LRN-01-0412  
LCR S01-08

**EXIGENT REQUEST FOR CHANGE TO TECHNICAL SPECIFICATION 3/4.7.4  
SERVICE WATER SYSTEM  
SALEM GENERATING STATION UNIT NO. 1  
FACILITY OPERATING LICENSE DPR-70  
DOCKET NOS. 50-272**

SALEM GENERATING STATION  
UNIT NO 1  
DOCKET NOS. 50-272  
CHANGE TO TECHNICAL SPECIFICATIONS

FIGURE 1  
SALEM UNIT 1 SERVICE WATER SYSTEM

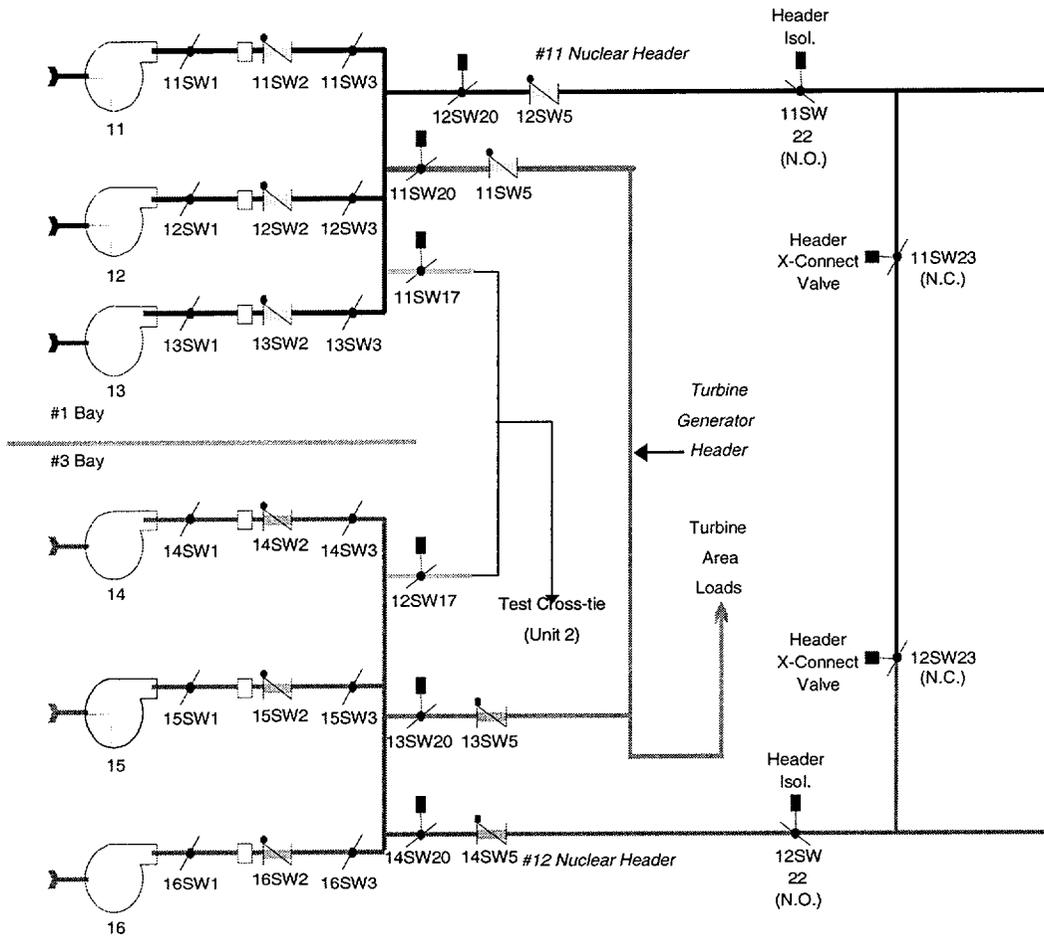
On Friday morning, November 30, 2001, Operations personnel noted water rising up through the gravel in front of the Service Water intake structure. The water was located approximately five feet from the structure and seven feet from the north side stairs, the 12 Service Water nuclear header is located below the location where the water was observed and was considered to be a likely source of the leak.

Subsequent investigation and troubleshooting determined that the leak is associated with the 12 Service Water nuclear supply header. This determination was partially based on the use of a dye test. Based on the information currently available, the leak is postulated to be at an underground mechanical joint or mechanical connection associated with the buried portion of the 12 Service Water nuclear supply header located near the Service Water structure. A simplified diagram of the service water system is provided in Figure 1.
